## NUCLEAR REGULATORY COMMISSION

## Title: Advisory Committee on Reactor Safeguards

Date: Thursday, December 4, 2025

17 Next slide. So we recognize the focus for  
18 today is the Palisades Steam Generator Operational  
19 Assessment for Cycle 29. We did want to start,  
20 however, with a summary slide to provide a high-level  
21 perspective upfront of the Palisades work as a whole.  
22 And since it's been a few months since September,  
23 since we last presented at ACRS, we thought it would  
24 also be beneficial if the OA discussion was preceded  
25 by some slides that relate to the steam generator

# Vertical and Horizontal (Eggcrate) Supports

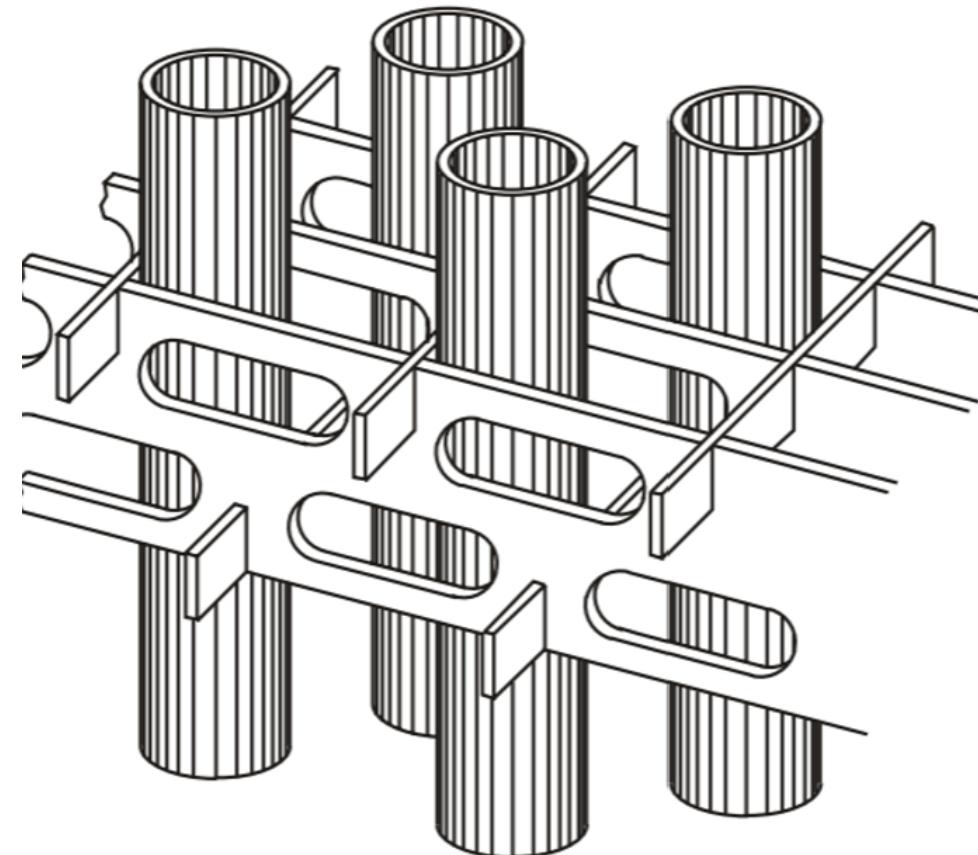
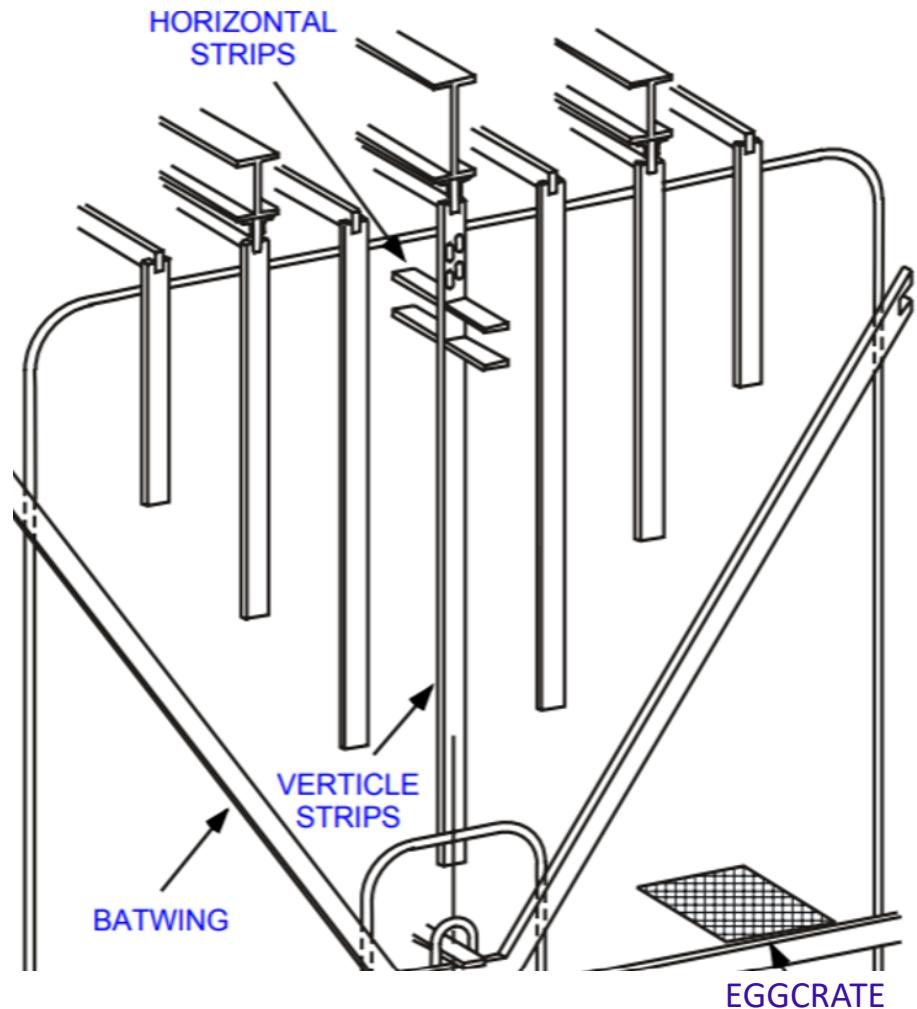
23 This just shows the Palisade's Model 2530  
24 steam generators. I think, in one of our earlier  
25 presentations, we were asked if we could show some

1 schematics to give the committee a better  
2 understanding of the generators. And as you can see  
3 on the left side, the horizontal supports are labeled,  
4 once you get above the tube sheet level, 1H up to 8H.  
5 The actual sleeves were inserted from 01H up to 05H.  
6 And in terms of the preventative strategy that they  
7 used, because, once you sleeve a tube, you can't get  
8 in in the future to a higher elevation to sleeve at a  
9 higher support, they tended to sleeve from 01H to 05H  
10 and a lot of the tubes where they had indications.  
11 And that's how they ended up with approximately twice  
12 as many preventative sleeves as corrective type  
13 sleeves.

# CM – Axial ODSCC at Eggcrates SG B

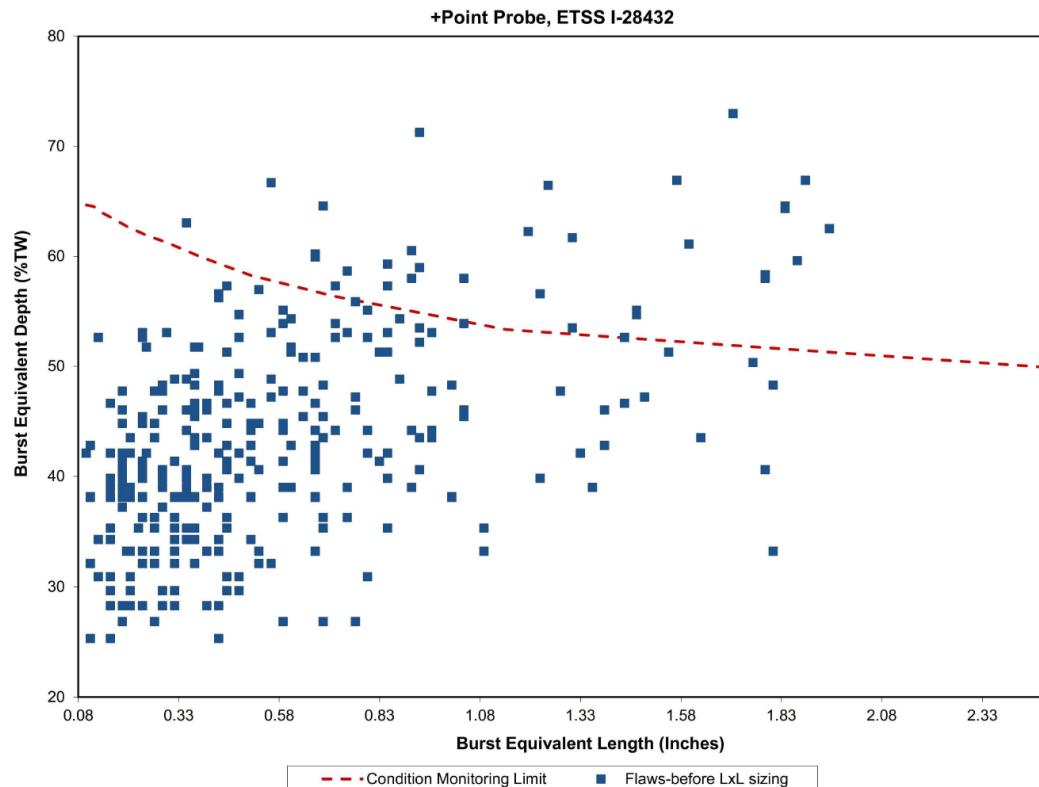
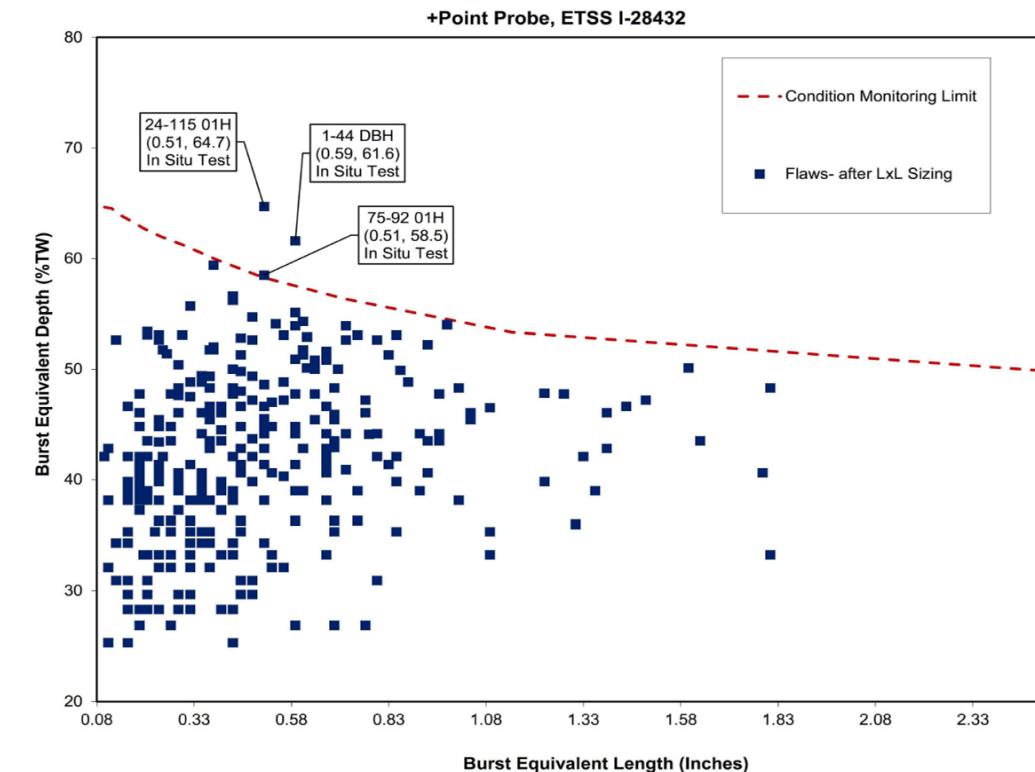
7 MR. KLEIN: Okay. This schematic shows an  
8 example of how the more detailed eddy current or flaw  
9 profiling is used as part of the condition monitoring  
10 process. So this is a snapshot of condition  
11 monitoring of steam generator B for axial ODSCC at  
12 eggcrate supports. And if you look on the left chart,  
13 each of those data points would indicate an indication  
14 that was detected in size by eddy current. On the  
15 right side, this would show that same data but now  
16 with the benefit of the flaw profiling. So you would  
17 essentially take each slice of data and try to develop  
18 a flaw profile so that you can better map the actual  
19 crack profile. And when you do that, you'll  
20 oftentimes find that initial sizing oversizes the flaw  
21 and you can see that there's relatively few flaws at  
22 this point at or above that condition monitoring line,  
23 which is shown by the red dashed line. And those

Figure 8-4: Palisades SG A Tube OD Deposit Loading 20.0 mils and thicker

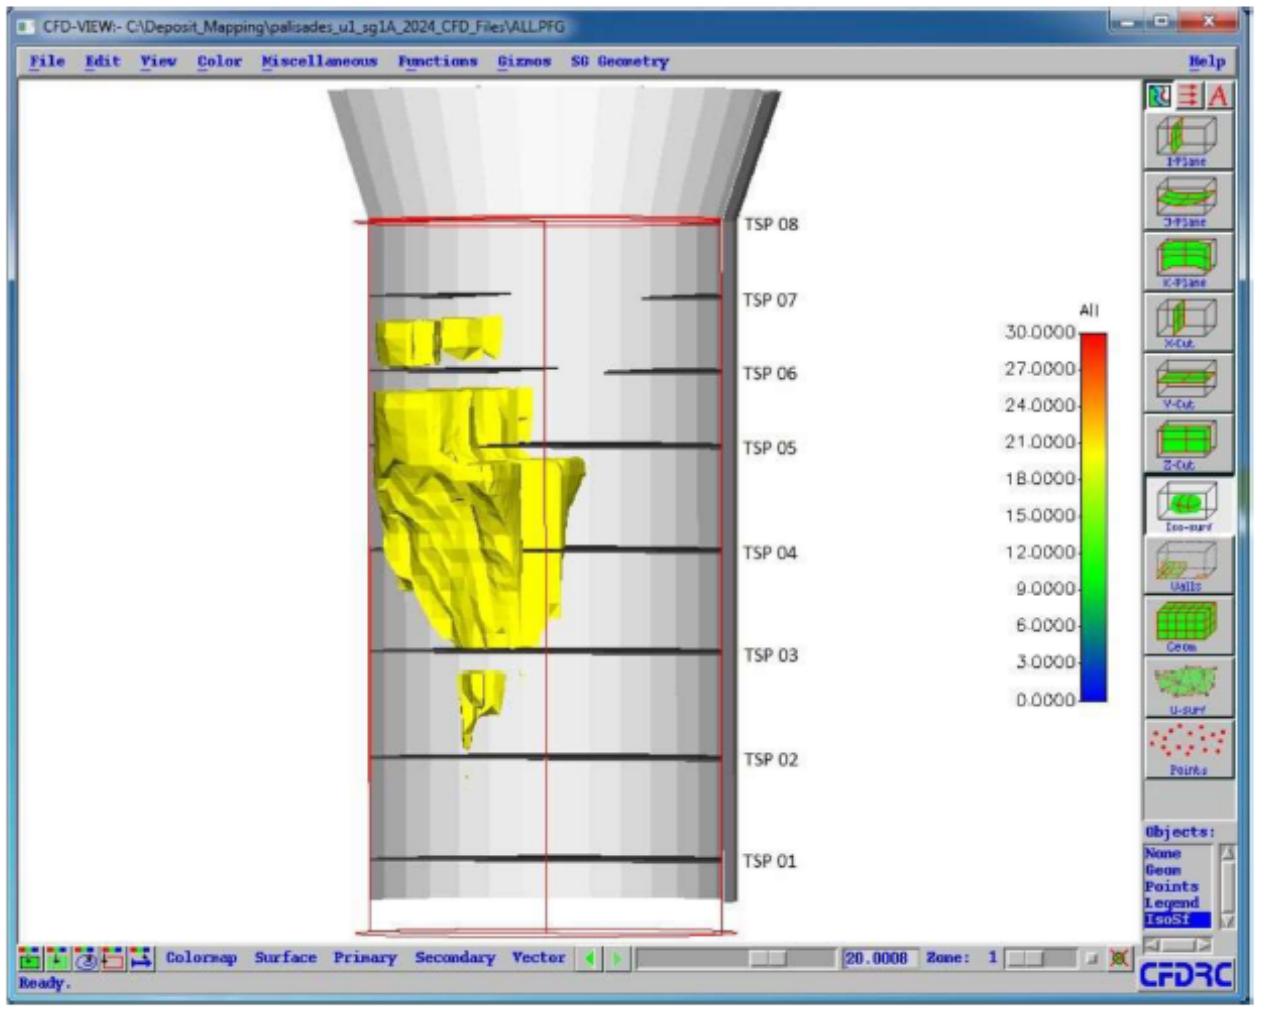
5 MR. KLEIN: The next slide here shows a  
6 profile of outside diameter deposits from steam  
7 generator A. And in this case, this schematic shows  
8 deposit loading of 20 mils and thicker, as shown in  
9 the yellow highlights on the left chart here. And so  
10 deposit mapping is done in most plants to understand  
11 the condition of the tubes and to determine when it  
12 might be appropriate to do chemical cleaning. And I  
13 think what you see here on the left side shows that  
14 the highest deposit loading tended to be from above  
15 the third support up to about the seventh there.

16 The right part of this slide, which was  
17 taken from the apparent cause analysis from the plant,  
18 shows the support number with the bottom support, 01H  
19 up to 05H, in terms of the number or percentage of  
20 total eggcrate cracks that occurred at that location.  
21 So you can see from the chart to the right compared to  
22 the highest deposit loading on the left, the chart on  
23 the right suggests that it's a temperature-driven  
24 mechanism, which is consistent with cracking at  
25 temperature at the eggcrates. The 01H and 02H have

Figure 6-10: Model Indications and Detections vs. Actual Detections:  
Eggcrate, Vertical Strap, and Freespan Axial ODSCC

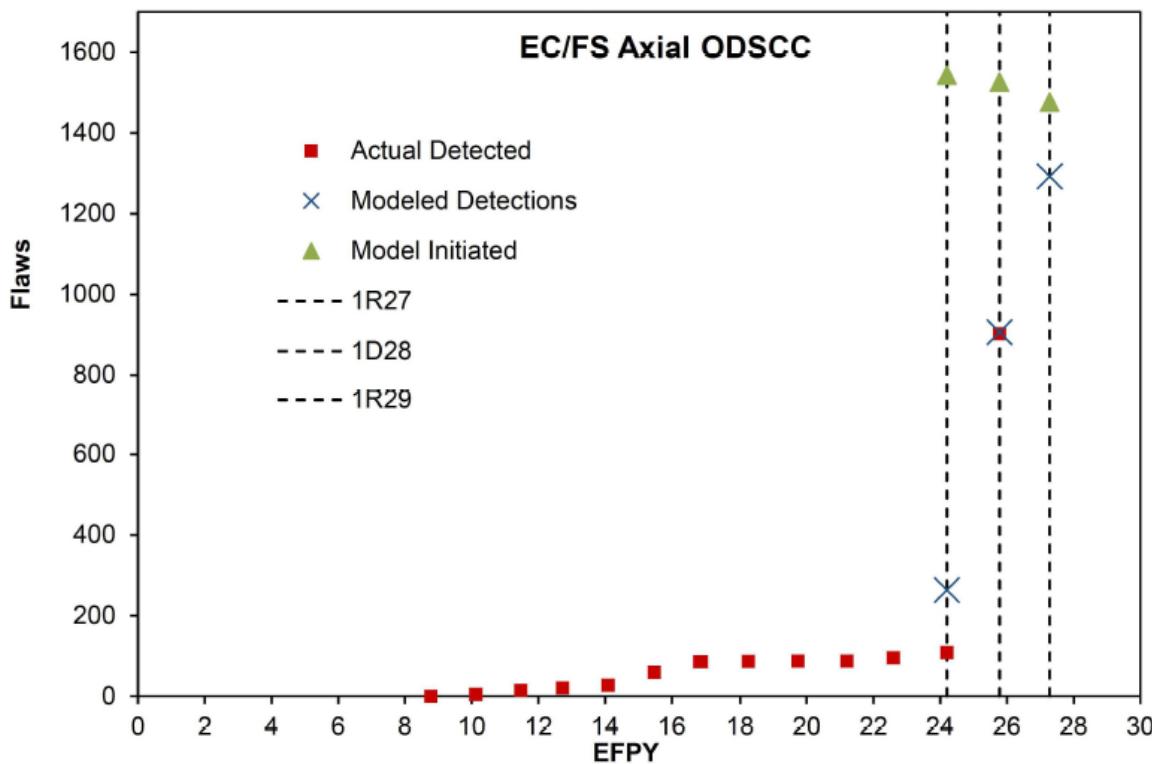
4 MR. KLEIN: Correct. So this slide is  
5 figure 610 from the operational assessment, and this  
6 shows the probabilistic modeling for steam generator  
7 A, which, of course, bounds steam generator B. And so  
8 what you see on the plot here are a number of  
9 different inspections shown by the red dots. And if  
10 you look at prior to 1R27, which is shown here on the  
11 vertical line, it's close to about 24 EFPY. So prior  
12 to that it assumed perfect detection, and then at 1R27  
13 is when it first initiated. You can see in the green  
14 triangle here shown at the top that the model now  
15 initiates a large number of new indications, cycle  
16 between 27 and 28. And because of that, you then have  
17 this large increase in number of indications that is  
18 benchmarked by the model here shown around EFPY 26.  
19 You can see that the predicted detections and actual  
20 detections match at that point, and that's part of the
